**Our Case Number:** ABP-317560-23

**Re:** Proposed windfarm development including 13 no. wind turbines in Bunnyconnellan, Co. Mayo and hydrogen plant in Castleconnor, Co. Sligo.  
Carrowleagh, Bunnyconnellan, Co. Mayo and Curraun, Castleconnor, Co. Sligo.

## INVITED OBSERVATION

## Observation re PA16.317560-23 (Mayo and Sligo County Council's)

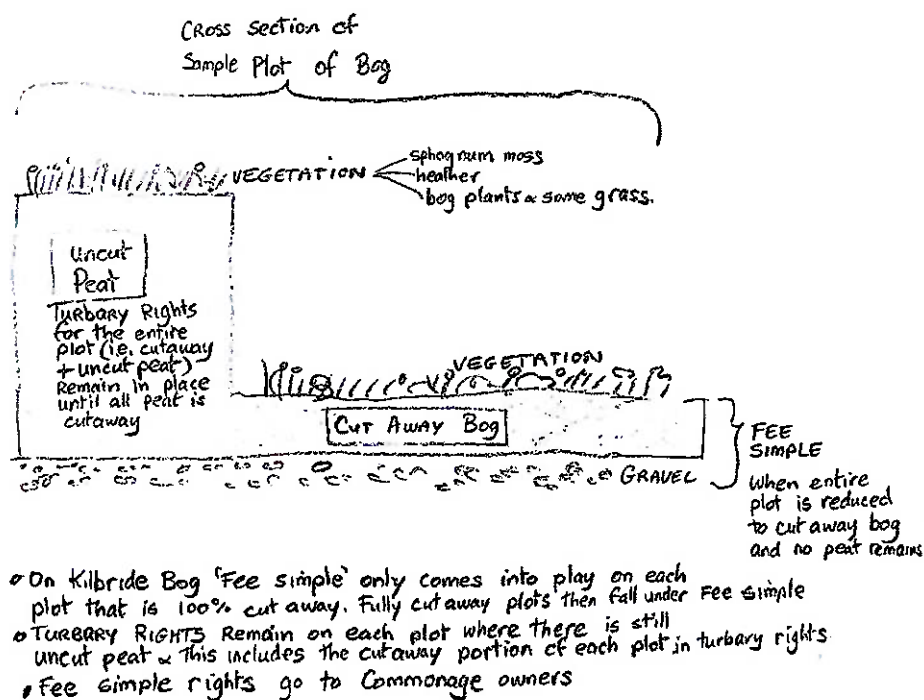
8. DRAFT Firlough Wind Farm FRA Project no. 603676-Hydro-R02-- (00) mentions 'underground electrical and communications cabling connecting the wind turbines to the wind farm substation' Appendix 9.1 ground water assessment

Where are the drawings for these?

Does the location of these cables affect turbary rights?

It is submitted that consents need to be in place for these. There don't appear to any letters of consent for same from owners of turbary rights.

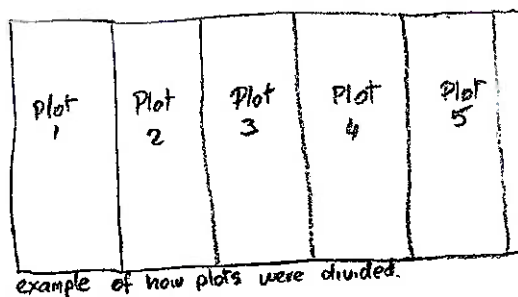
9. The Land Commission allocated turbary rights and commonage on Kilbride Bog (also referred to as Carrowleagh). This bog is where the applicant proposes to develop a wind farm. It is our understanding that turbary rights to a plot of bog, remain in place for that entire plot, (i.e. bank of turf and cutaway area), until such time as the entire plot is cut away. Rights of commonage cover the surface area of the bog for grazing. It is our understanding that the Land Commission decided that 'Fee Simple' comes into play on each plot that is entirely cut away and no peat remains for harvesting. In the case of this bog, this effectively means that commonage owners have the rights to the plots that are fully cut away, but not plots that still have peat remaining. My clients prepared the following diagram to demonstrate this point

example of how plots were divided.

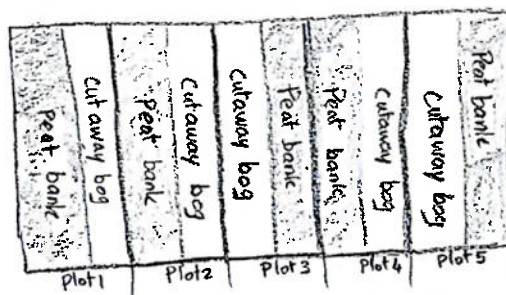
- Turbary Rights to harvest Turf Plots were allocated by number to houses in the area & many to Ballina Town householders
- Bog plots are not typically 50m x 180m as stated by the developer
- There are not over 620 plots as stated by the developer.

- Turbary Rights owners have cut turf on their plots. There is no rule for where they cut on their plots so the pattern throughout the bog is that of plots with strips of peat with strips of cut away bog.
- Therefore Fig. 5.3 does not represent this correctly. Figure 5.3 Habitats map is misleading and shows vast areas of cutover bog.

My clients are not satisfied that Figure 5.3 of the EIAR is a true representation of the existing banks of turf.

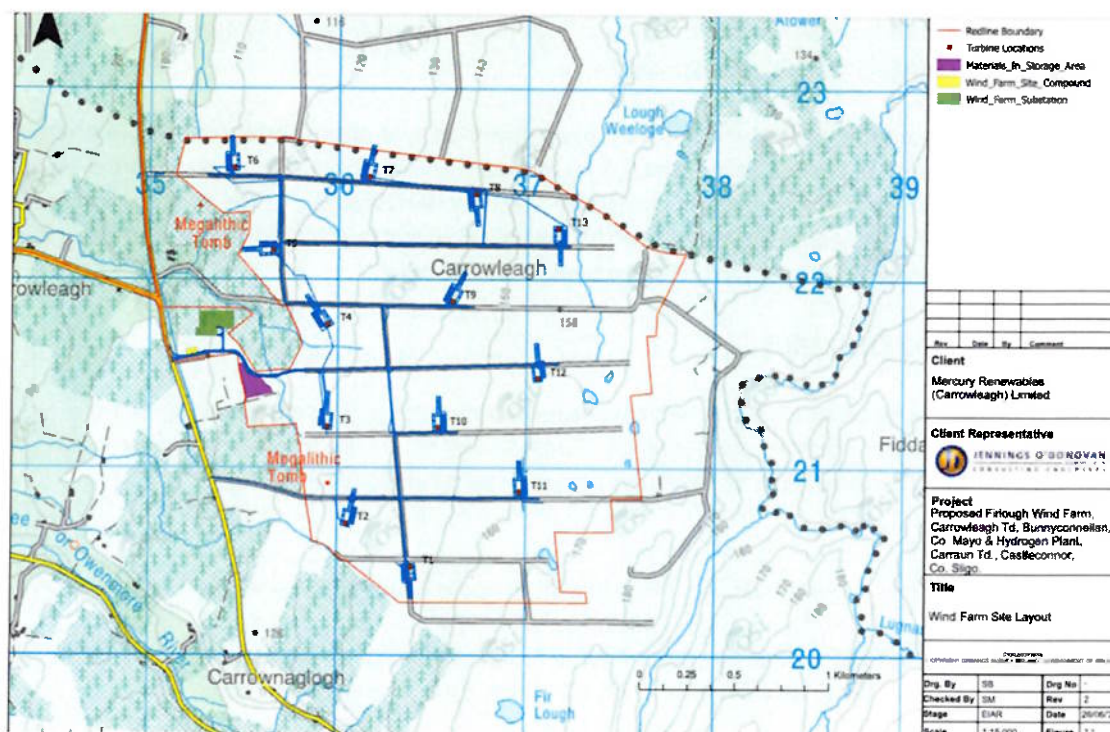
12. It is difficult to understand what is meant by the above paragraph when it is read in conjunction with the below Wind farm Site Layout. Why is there no mention of T5? We seek clarification of this.
